**DOMINION NUCLEAR CONNECTICUT, INC.**  
**MILLSTONE POWER STATION UNIT 3**  
**RESPONSE TO REQUEST FOR ADDITIONAL INFORMATION**  
**REGARDING RELAXATION REQUEST IR-2-46, REACTOR PRESSURE VESSEL**  
**HEAD INSPECTIONS, (TAC NO. MD1735)**

**RELAXATION REQUEST IR-2-46,**  
**REACTOR PRESSURE VESSEL HEAD INSPECTIONS**  
**(TAC NO. MD1735)**

**RESPONSE TO REQUEST FOR ADDITIONAL INFORMATION**

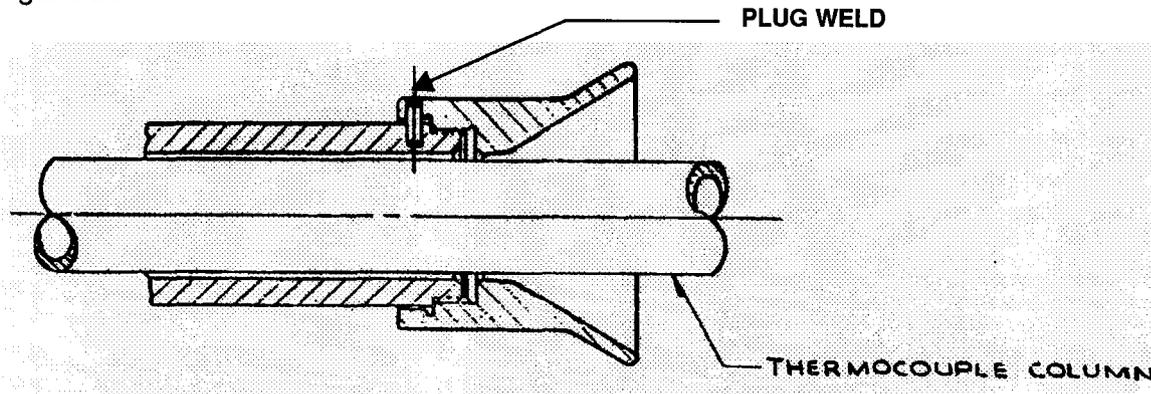
### **NRC Question No. 1**

Provide details of the attachment of the guide funnel to the nozzle, including details of the weld length, size, filler material type, etc.

**NRC Question No. 3**

When determining the operating stresses in the nozzle at the top of the guide funnel, how will the weld attaching the guide funnel to the nozzle be taken into consideration?

The guide funnel to the nozzle is essentially a threaded attachment, as is shown in the figure below.

Detailed drawings that are being used to plan for this inspection provide a detail that shows a plug-welded pin through the guide funnel. The assembly drawing shows the pin and threading that are used to attach the guide funnel to the nozzle. Therefore, DNC concludes that the nozzle material was not welded to attach the guide funnels.

**DNC Response**

The operating stresses in the nozzle are not affected by the use of a plug weld on the guide funnel. Refer to the figure in response to NRC Question 1.
